Access Compliance Report

Public Rights-of-Way

(Curb Ramps)

| ADA ID: 6235383883E1 | Ramp Type: Directional1 | Initial Pass/Fail: Fail | Overall Compliance: No |

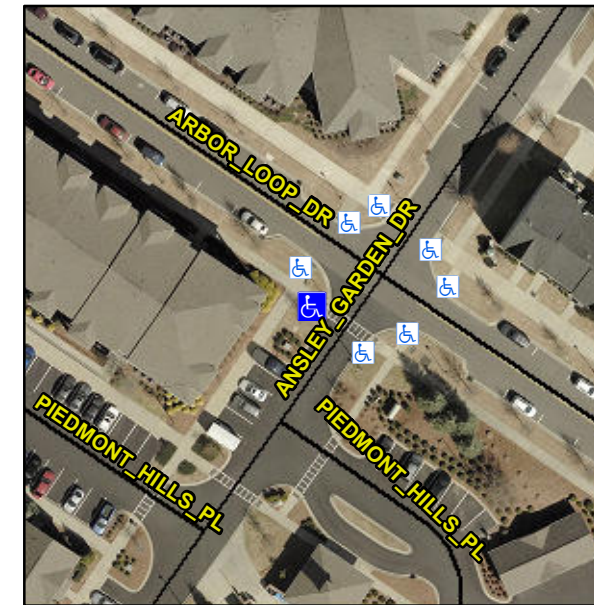
R304.5.3

| Compliance | Description | Data | Compliance | Description | Data |
|------------|-----------------------|------|------------|-----------------------------|------|
| No | Ramp XSlope (%) | 2.9 | | | |

Remove & Replace Entire Ramp.
